MIL-L-970/10A(SHIPS)
18 November 1966
SUPERSEDING
MIL-L-970/10(SHIPS)
17 June 1966

MILITARY SPECIFICATION SHEET

LAMPHOLDER, MINIATURE BI-PIN FOR FLUORESCENT LAMPS

SH8394B

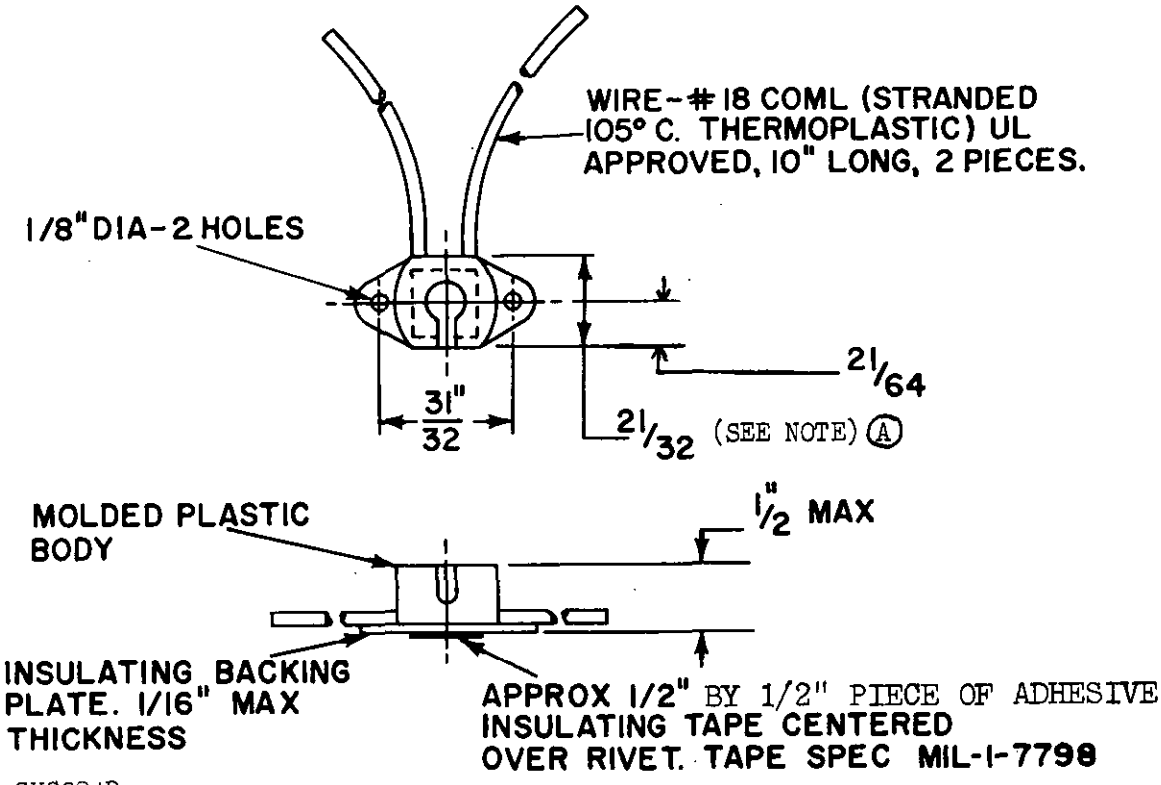
(A) NOTE:
When this lampholder is used by lighting equipment manufacturers for new design construction, this dimension may be varied up to a maximum of 3/4 inch. When supplied as a replacement part, this dimension shall be maintained as shown.
